# Technical Service Information

## GM 5L40E / BMW A5S360R

### DELAYED FORWARD ENGAGEMENT

Figure 1

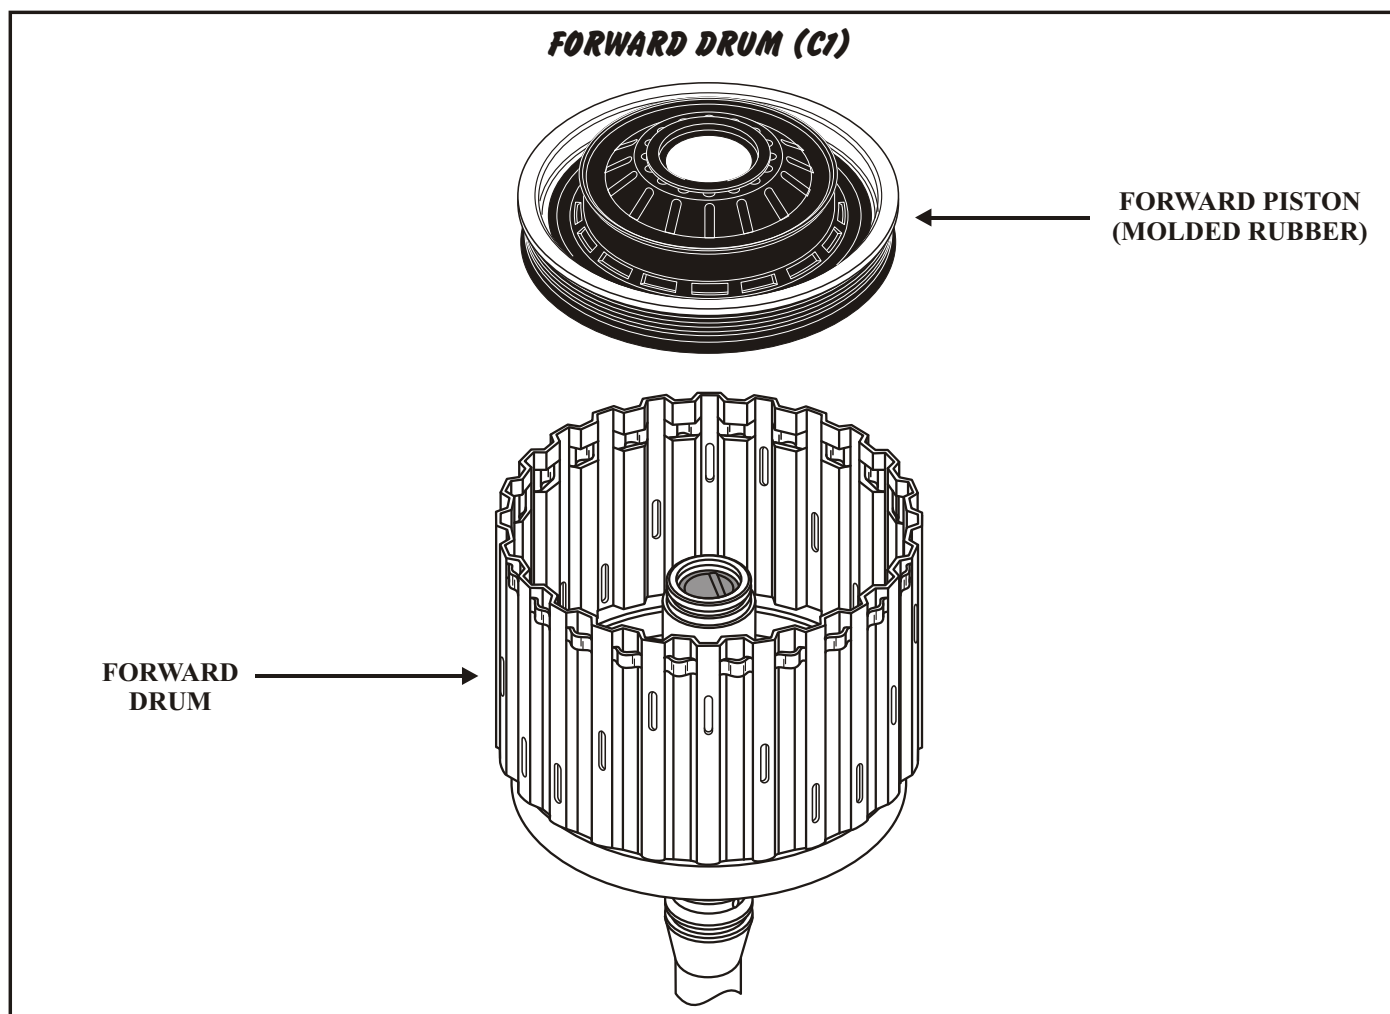
- COMPLAINT:** Some BMW “E” series and Cadillac CTS models built from 09/02 to 12/03 may exhibit a delayed engagement from park to drive when cold. The delay may last anywhere from two to thirty seconds.
- CAUSE:** The forward drum (C1) was manufactured with improper tolerances that cause the clutch piston to not make a good seal between it and the clutch housing when the vehicle is parked for a prolonged period of time, such as overnight. Therefore on the initial start, the forward clutch does not apply.
- CORRECTION:** Since internal parts are not available, a reman transmission will be necessary. Because the manufacturer does not disclose any build code information, it is impossible to tell which drum would be a good one if used parts are acquired.
